March 30, 2022

Subject: Site Investigation Report and Remedial Action Plan Review
Approval to Manage Contaminated Soil Under Wis. Admin. Code § NR 718.12 on Site
Innovation Park Lots 2, 3, 4 and Outlot 3, 9480 Watertown Plank Road, Wauwatosa, WI
BRRTS #02-41-588671, FID #341030690

Site Investigation Report and Remedial Action Plan Review

SITE PLAN MAP
IRGENS INNOVATION PARK DEVELOPMENT
WAUWATOSA, WISCONSIN

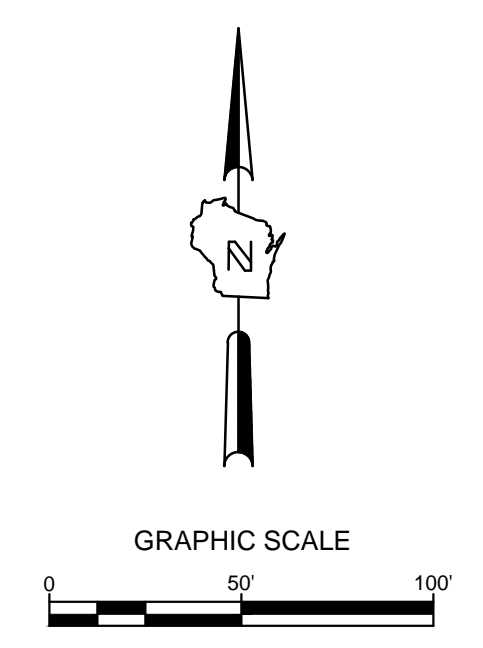
The DNR is currently only responding to the area outlined in red including Lots 2, 3, 4 and Outlot 3, as depicted on Figure 2 submitted as part of the Report. There are documented RCL exceedances in borings on Lot 1 and Outlot 2. Release notifications must be submitted for these lots immediately. These areas, in addition to Outlot 1 and Outlot 4, are currently part of a single property with the same contaminant source (reworked soil/fill) that will require investigation and possibly remediation and/or continuing obligations.

1. Discuss why the tetrachloroethene (PCE) detection in soil is not a concern.
2. The source of soil contamination is property-wide reworked soil/fill material. It must be inferred that soil with RCL exceedances could be present across the property and the extent of contamination RCL lines and the cap must extend over the entire redevelopment area. This should also be included in the finalized cap maintenance plan.

FIGURE 15

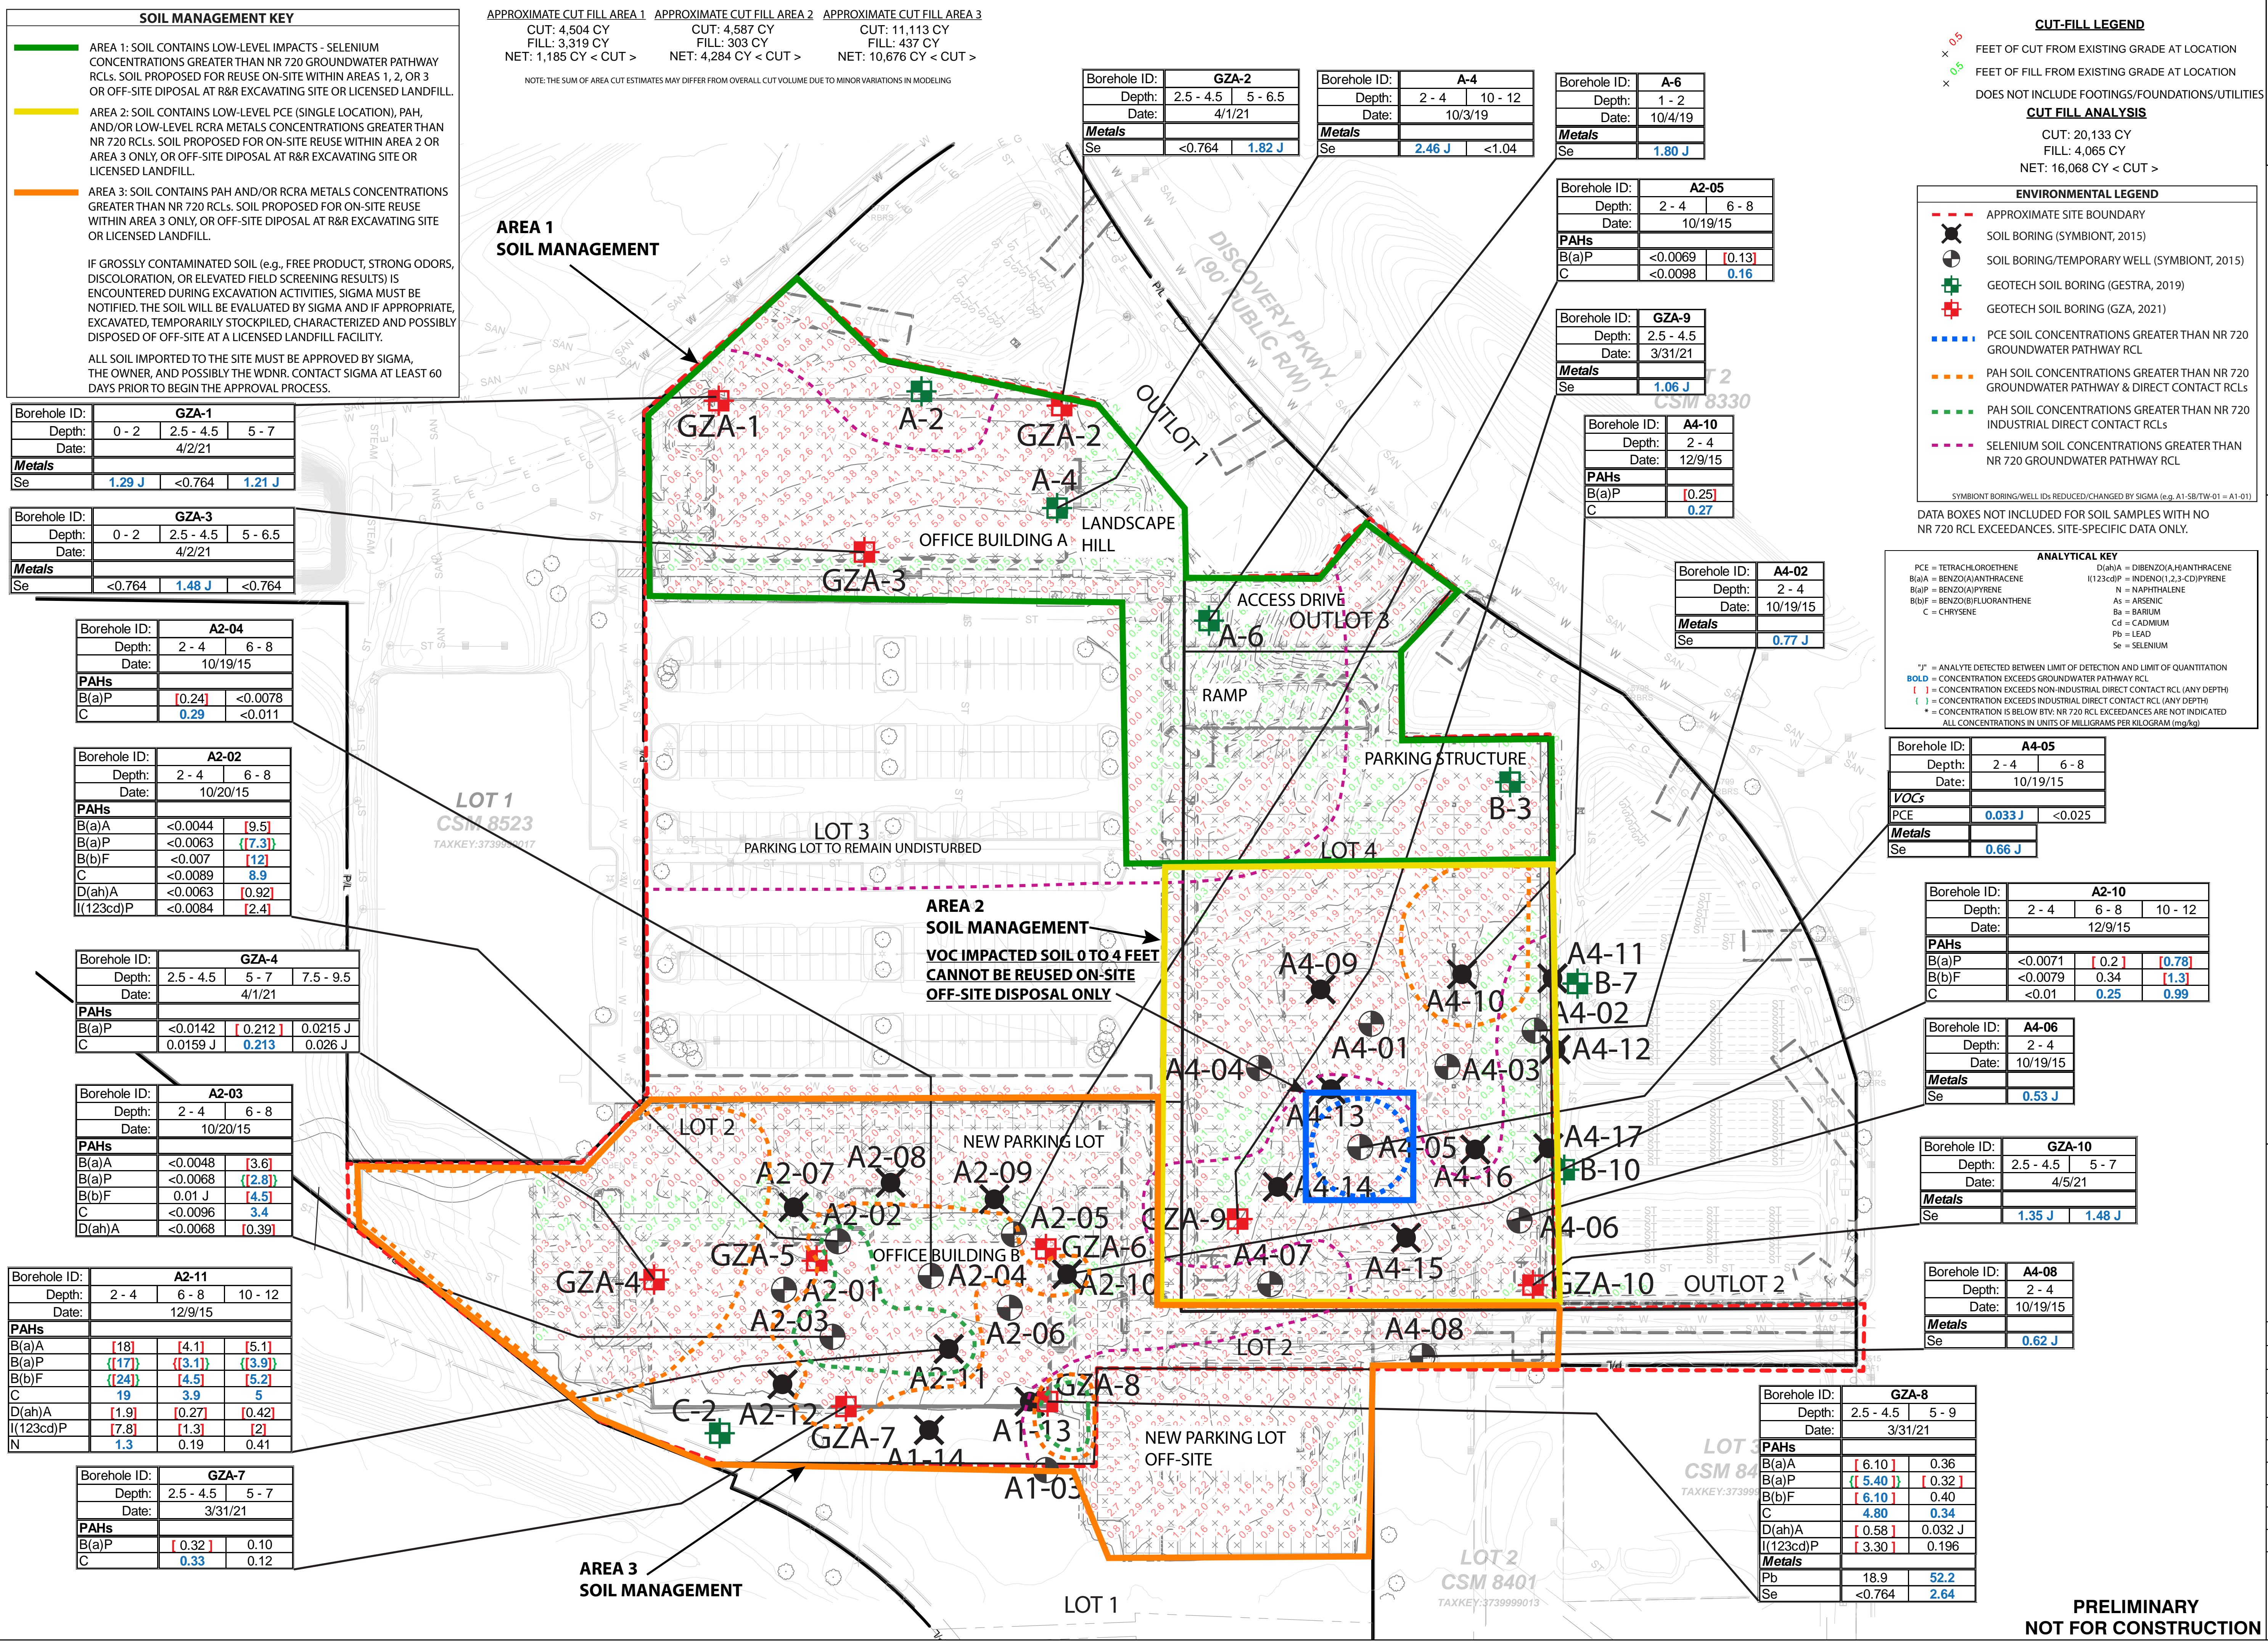
Managing contaminated soil in areas of the site identified on Figure 15 of the Report will meet the locational criteria listed under Wis. Admin. Code § NR 718.12 (1) (c), exception for the following:

- Within 3 feet of the high groundwater level

Grant of exemption to Wis. Admin. Code § NR 718.12 (1) (c) 5

In consideration of the material staying within project limits, that it will be capped and is not expected to impact groundwater, the DNR grants an exemption to the location criteria of Wis. Admin. Code § NR 718.12 (1) (c) 5 and will allow placement of contaminated material in this location.
